**From:** Planning\_THM  
**Sent:** 06 August 2020 11:49  
**To:** Michael Sackey <Michael.Sackey@Cherwell-DC.gov.uk>  
**Cc:** Planning <Planning@Cherwell-DC.gov.uk>  
**Subject:** RE: Planning notification for application reference: 20/01942/F

**Improvement of community facilities at Wendlebury Village Hall comprising construction of a disabled toilet, garage for community mini-bus, installation of bifold doors to rear of Hall (Re-submission of 18/01363/F)**

**Wendlebury Village Hall Main Street Wendlebury Bicester OX25 2PS**

As you can see from the image below, the approved Proposed Plans and Elevations drawing, reference BW006/02 includes a measurement for the height of the proposed voids of 0.762m.

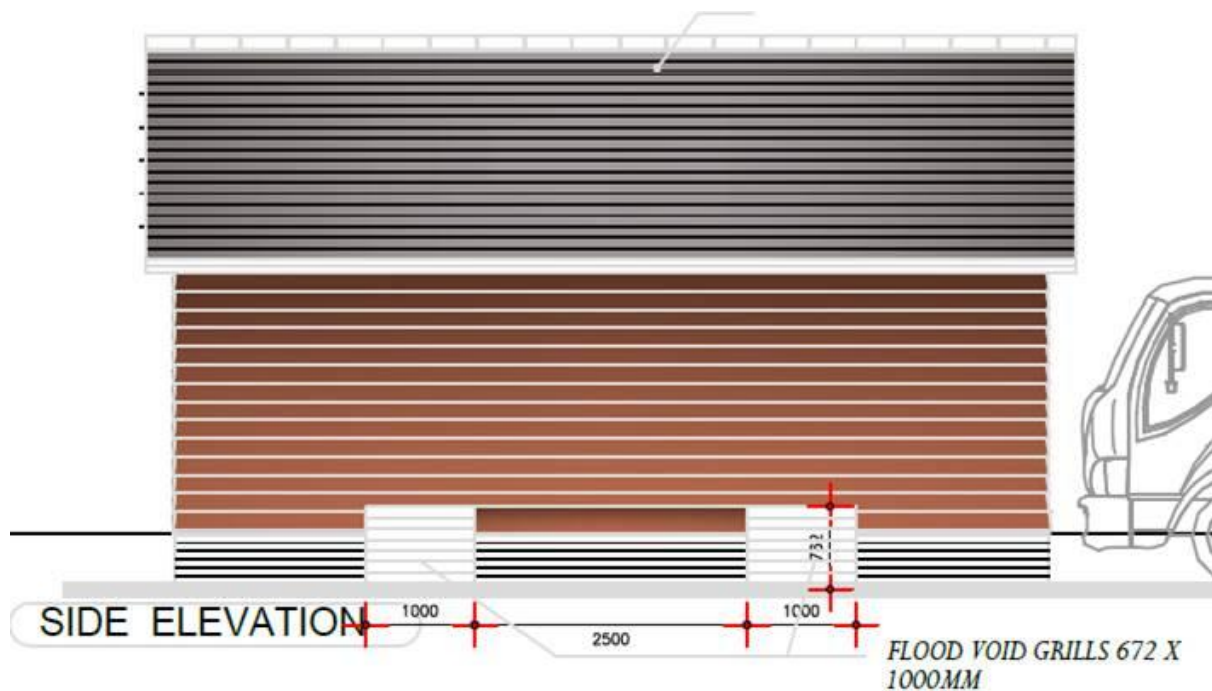
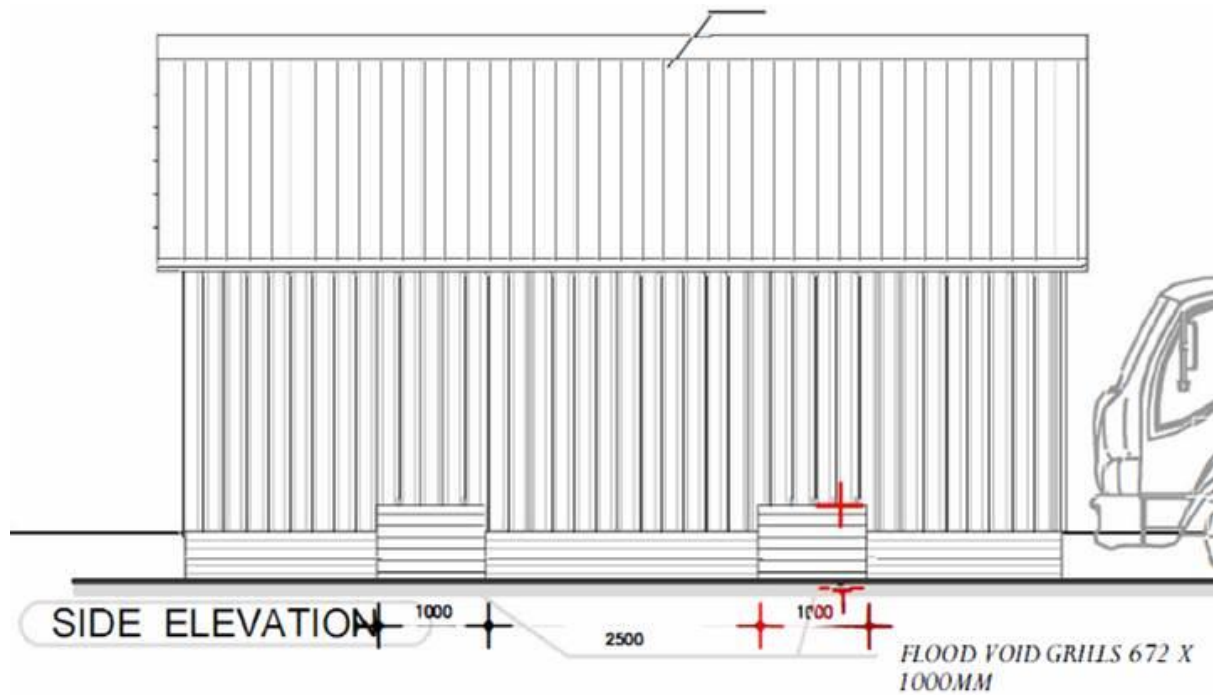
However, the submitted amended drawing is missing measurements for the proposed voids.

However, as you can see from the amended drawing (Proposed Plans and Elevations drawing, reference BW006/02, rev A), no measurement has been included.

At this present time we are unable to agree to this proposed variation of conditions until the measurement mentioned above has been included on the amended drawings.

Please can you ask the applicant to amend these drawings and forward these onto me once you have received them.
